Access Compliance Report

Public Rights-of-Way

(Curb Ramps)

Intersection ID: 45682	Main Street: SOUTHPARK_LN	Cross Street: PARK_SOUTH_DR	Location: SE
ADA ID: 9A3003A2AB9F	Ramp Type: ParaDiag	Initial Pass/Fail: Fail	Overall Compliance: No
			Severity Score: 26.25

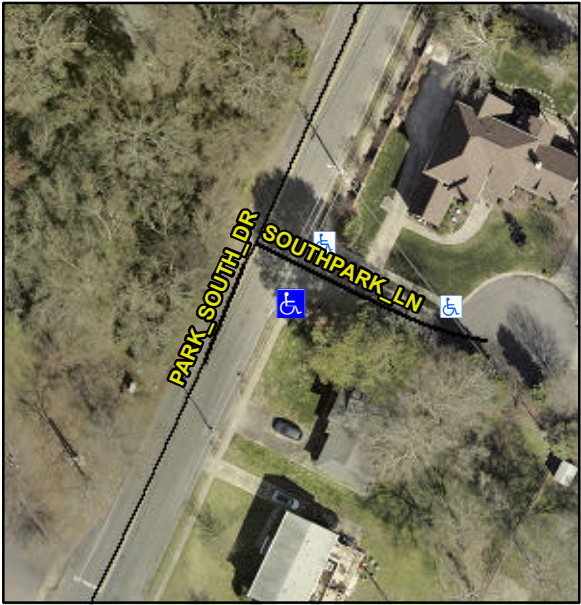
Codes/Mitigation Info/Possible Solution			Field Measurements/Component Compliance		
	Possible Solutions:		Compliance	Description	Data
	Remove & Replace Curb Ramp With Two New Directional Ramps or Equivalent.		N/A	Ramp Length LT (in)	43.0
			Yes	Ramp Width LT (in)	86.0
			Yes	Ramp Slope LT (%)	0.9
			Yes	Ramp XSlope LT (%)	0.6
			N/A	Landing Length (in)	N/A
			N/A	Landing Width (in)	N/A
			N/A	Landing Slope (%)	N/A
			N/A	Landing X Slope (%)	N/A
			N/A	Landing Curb? (Y/N)	N/A
<p>Surveyor Notes:</p> <p>LT RP < 5%</p> <p>PROW/ADA:</p> <p>R304.3.2, R304.5.3</p>			N/A	Ramp Length RT (in)	40.0
			Yes	Ramp Width RT (in)	84.0
			No	Ramp Slope RT (%)	14.2
			No	Ramp XSlope RT (%)	2.5
			N/A	DWS Provided?	N/A
			N/A	DWS Contrast?	N/A
			N/A	DWS Length (in)	N/A
			N/A	DWS Full Width?	N/A
			N/A	DWS Offset (in)	N/A
			N/A	Gutter Slope (%)	N/A
			N/A	Gutter Lip Ht (in)	N/A
			N/A	Painted X Walk1?	No
				X Walk 1 Direction	To W

N/A	X Walk 1 Width (in)	N/A
				X Walk 1 Slope (%)	1.6
				X Walk 1 X Slope (%)	3.5
			N/A	Ramp inside XWalk1?	N/A
				Road Slope (%)	4.5
				Road X Slope (%)	1.2
			N/A	Any Obstructions?	N/A
				Obstruction Type	
			N/A		N/A
			Yes	Surface Condition? (G/P)	Good
			N/A	Curb Slope (%)	25.8
